Addendum No. 2

State of Michigan
Department of Technology, Management and Budget
Ottawa Building-SIGMA Move to First Floor
File No:171/26231.ABG
October 16, 2026

THE PURPOSE OF THIS ADDENDUM IS TO ANSWER QUESTIONS RAISED DURING THE BIDDING PROCESS:

~~H. Gypsum Board Substrates – Scuff and Stain Resistant Systems~~

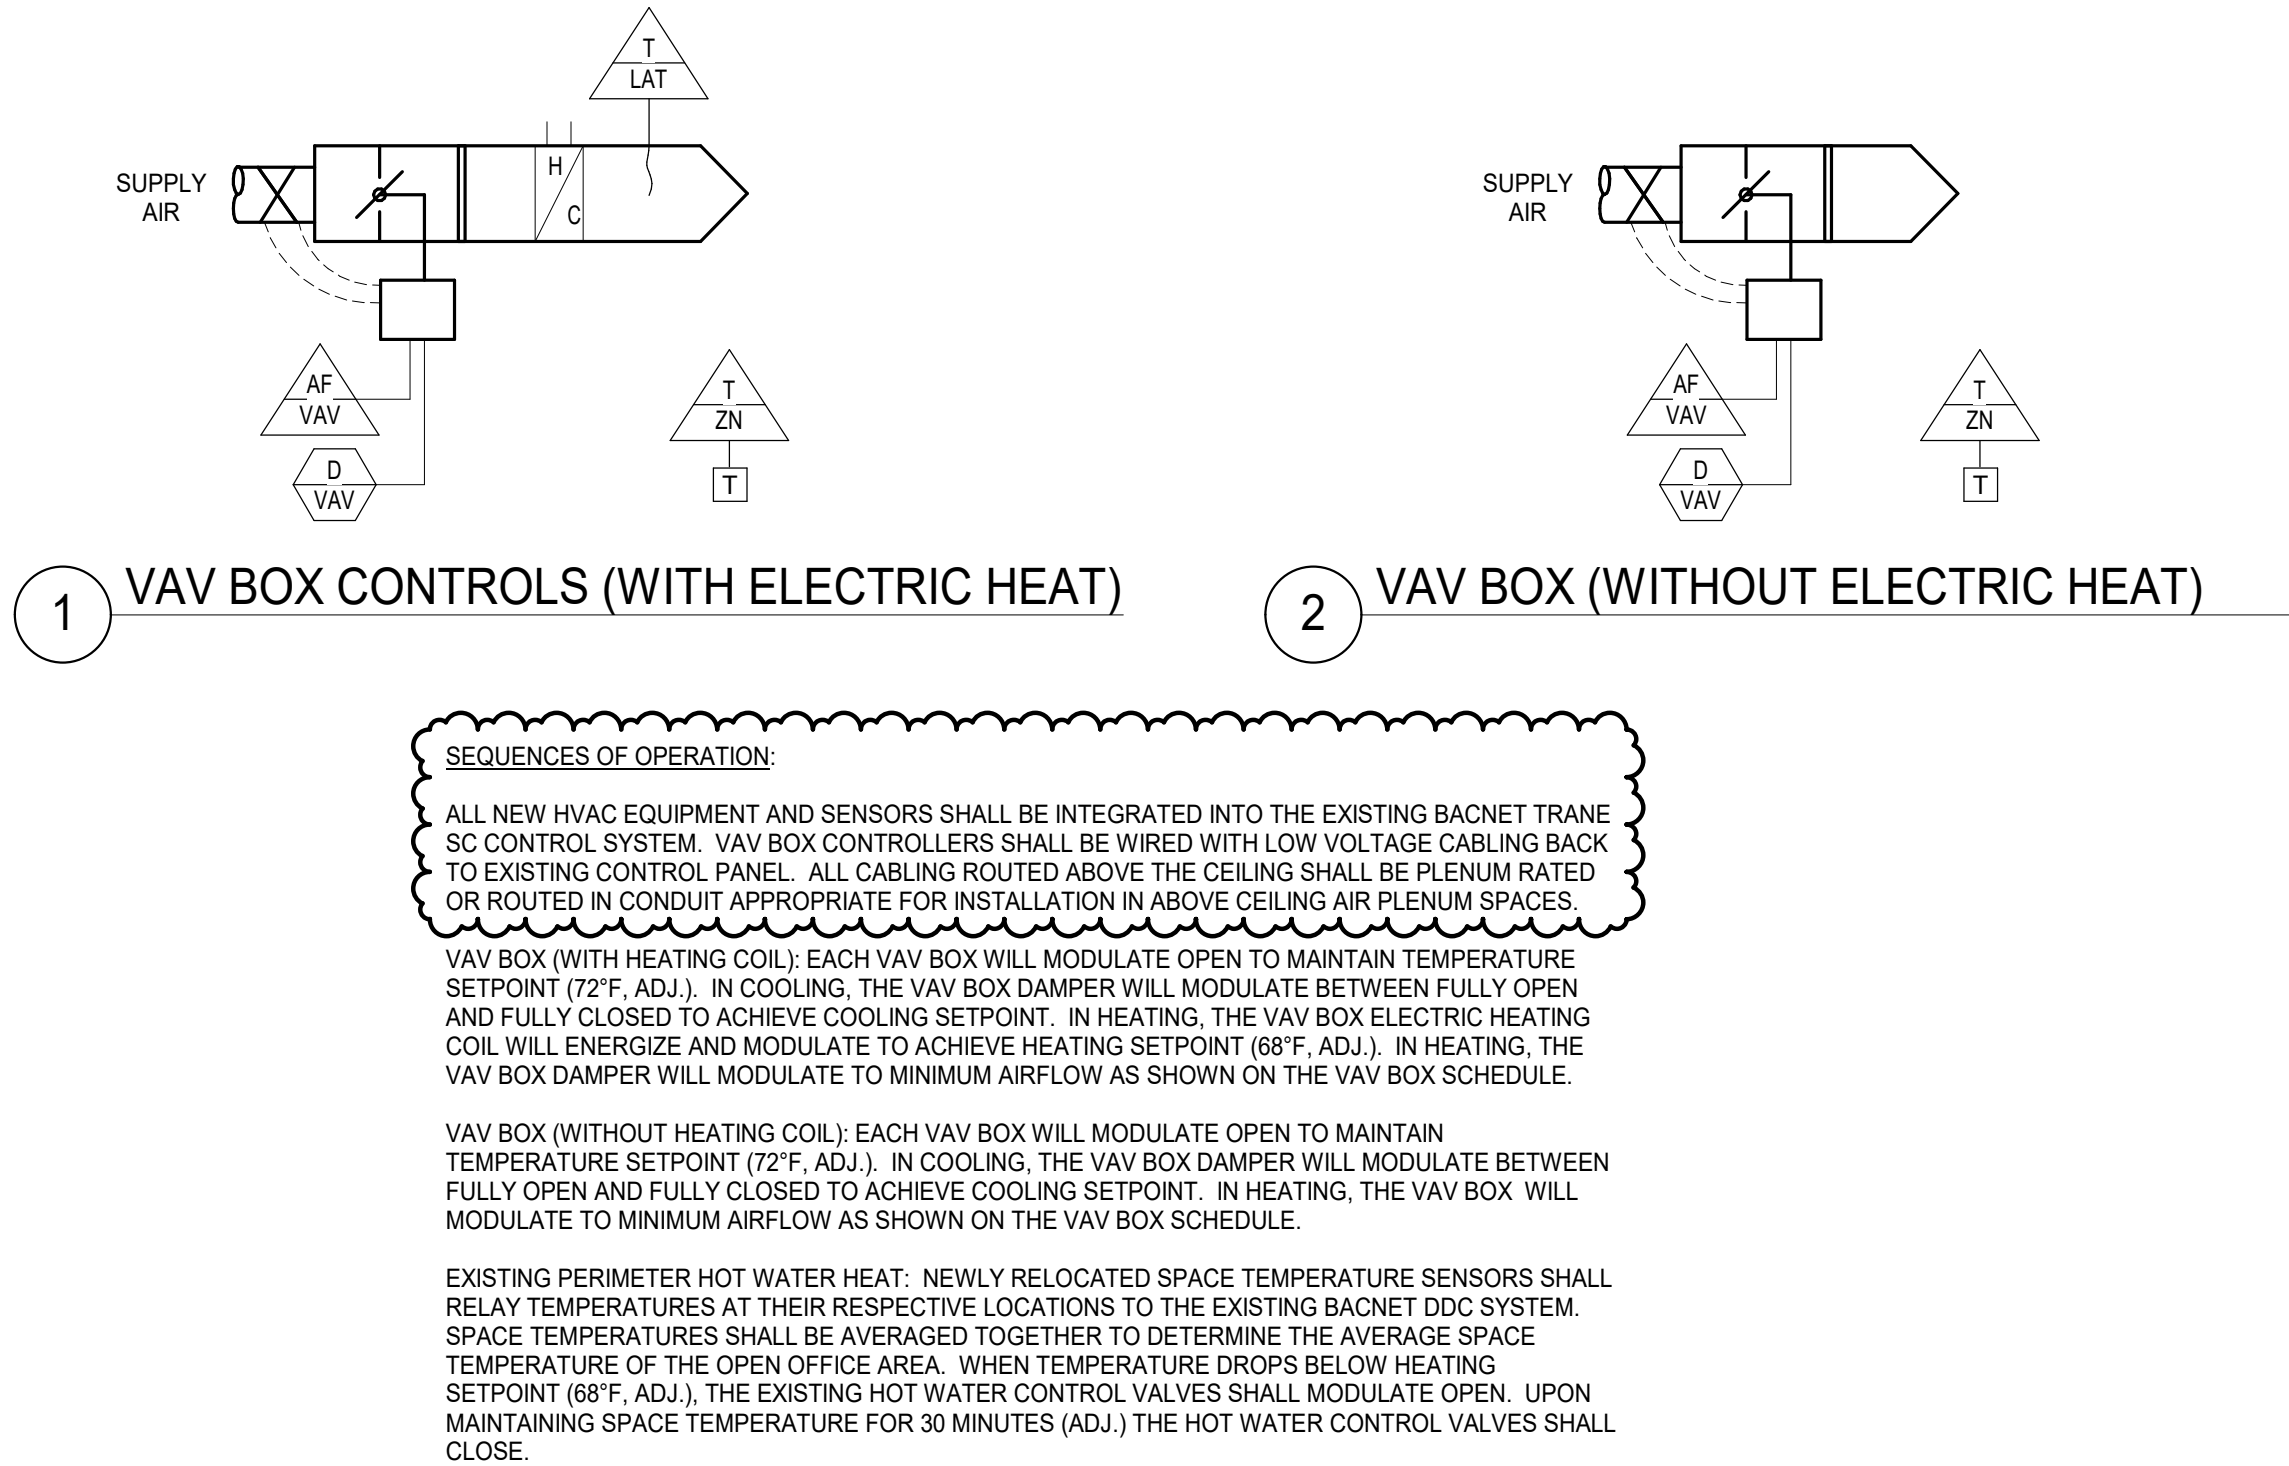
15. Question: Door and window frames: I'm counting 10 door-frame assemblies marked HM-PT, plus the separate clerestory window frames. Should we also include repainting any existing door frames or exterior window frames? Please confirm that the sidelights and transoms are included as well.
- Answer: *To provide continuity, all existing doors/frames/side lights should be painted/finished to match the new ones installed.*
16. Question: Scuff Master: The specifications include a Scuff Master coating system but I'm not seeing where it's called out on the finish plan. Is it required anywhere? If so, could you identify which rooms or surfaces should receive it?
- Answer: *Please disregard section in specification that pertains to Scuff and Stain Resistant Systems. This will not be applicable to this project. Revised specification shall be attached to this addendum.*

- ~~1. Water-based premium eggshell polyurethane formula.~~
- ~~2. Scrub cycles: 8,000 – ASTM D 2486.~~
- ~~3. Fire rating: Class A.~~
- ~~4. Antimicrobial: Microban antimicrobial.~~
- ~~5. Eggshell Polyurethane System:~~
 - ~~a. Prime Coat: Scuff Master primer/Sealer.~~

- ~~b. Intermediate Coat: to match top coat.~~
- ~~c. Top Coat: Scuff Master Scrub Tough Performance Paint with Microban.~~
